## Meeting Agenda Planning Commission

Marquis Parking Lot Expansion: GLUA-18-00031 (General Land Use Application), PARK-18-00001 (Parking Adjustment); SP-18-00119 (Site Plan and Design Review) with VAR-18-00002 (Type III Planning Commission Variance)

### STAFF REPORT AND RECOMMENDATION *Planning Commission Hearing: August 26, 2019*

**FILE NUMBER:** **GLUA-18-00031 General Land Use Application:** SP 18-00119 Site Plan and Design Review, PARK 18-00001 Parking Adjustment, and VAR-18-00002 Variance

Figure 3: Proposed Site Plan

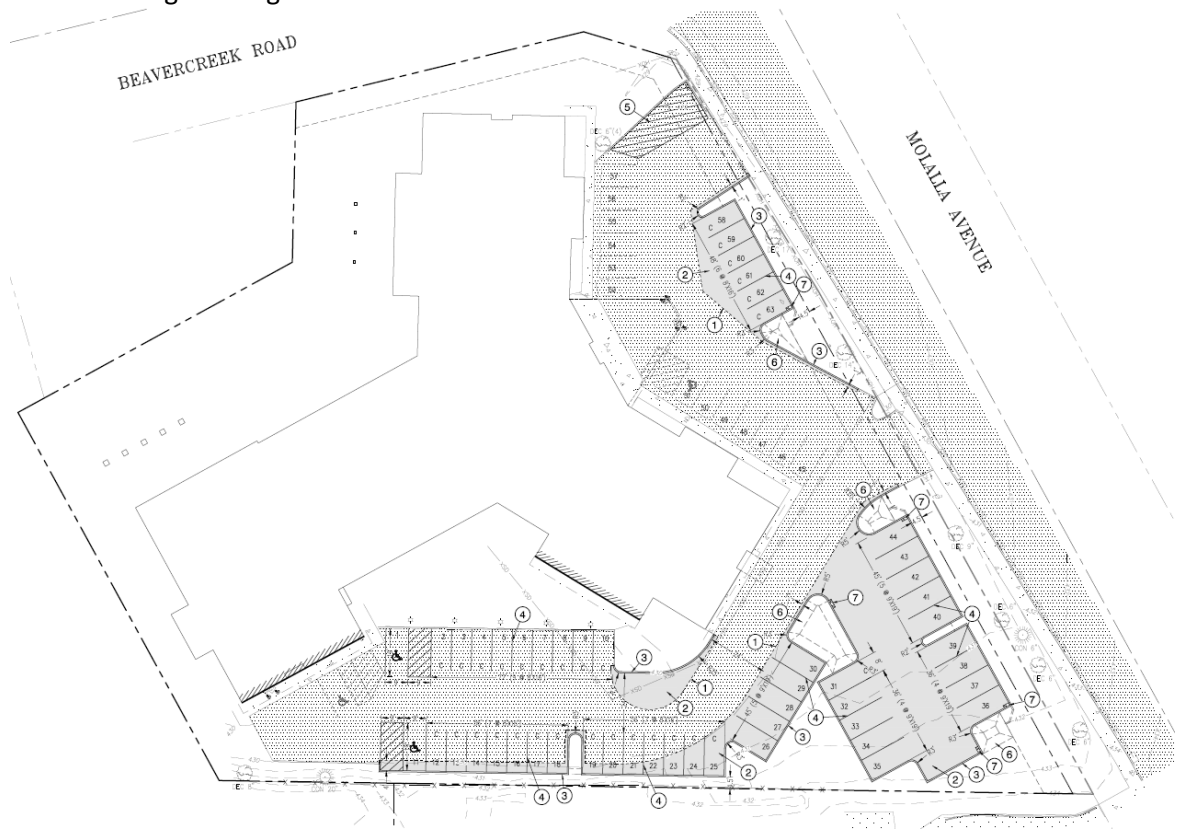
The applicant has proposed 20 additional parking spaces on site, adding to the existing 43 spaces. The proposal would remove eight parking spaces in front of the building and add 15 parking spaces in front of the building in a reconfiguration and expansion of the parking lot, with 13 spaces in front of the building remain. The proposal would result in a total of 28 parking spaces in front of the existing building.

18. The applicant shall redesign the northernmost driveway to reduce its width and provide only right-in right-out access. The final width shall be determined by the city engineering staff in consultation with emergency service providers. The applicant shall install signing in conformance with the Manual on Uniform Traffic Control Devices. The southernmost driveway shall be reconstructed to limit ingress and egress to only right turn maneuvers to and from Molalla Avenue; the driveway shall be signed in conformance with the Manual on Uniform Traffic Control Devices. (P)

19. The applicant shall, as part of nonconforming upgrades to pedestrian circulation, revise the plans to provide pedestrian access from the right of way that is clearly visible and distinguishable from vehicular access. (P)

21. The applicant shall provide pedestrian connections from the sidewalk to the front entrance and from the existing walkway in front of the building to the new parking area proposed in the southeast portion of the site. The applicant shall ensure that the required connections meet all of the requirements in 17.62.050.A.9.f. (P)

24. Prior to issuance of permits, the applicant shall include bicycle parking on the site plan and show details demonstrating that the parking is securely anchored in a convenient, secure, and accessible location, that the parking is separated from vehicle parking and maneuvering areas by 5 feet and does not obstruct pedestrian walkways, and is clearly marked or visible from the street, is connected to main building entrances, has direct access from a right of way, and is closer to the building than the nearest vehicle parking. (P)

Figure 4. Proposed Landscaping Plan

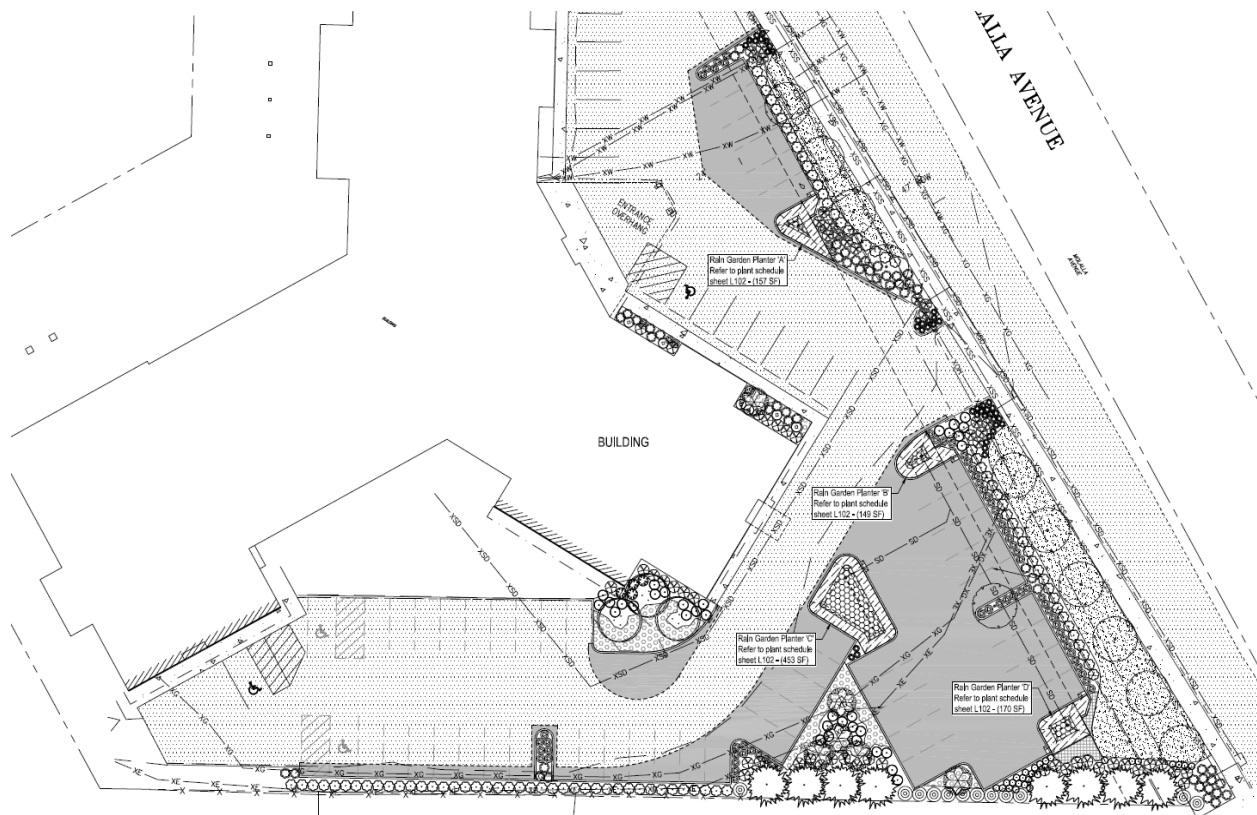
17. The applicant shall revise the landscaping plan to identify that the proposed plantings will cover 100% of the landscape area within 3 years nor that no mulch, bark chips, or similar materials will be allowed at the time of landscape installation except under the canopy of shrubs and within two feet of the base of trees. (P)
